NWK-OD-M 20 December 2023

MEMORANDUM FOR RECORD

SUBJECT: Use of New Army Star Logo on Select Corps Signs

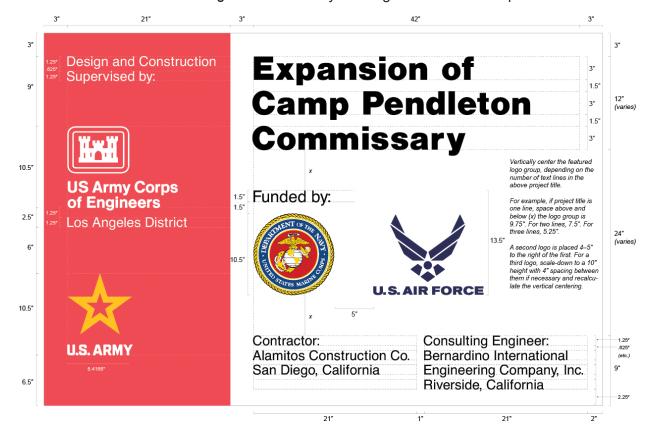
1. Standard Identification Sign: Note that the 8A minimum width above has been reduced from 8.5A in order to allow ample space between the text and the Army Star logo. Putting extra space between the end of the text and the .7A is permitted for the purpose of having the sign width round to the nearest foot.
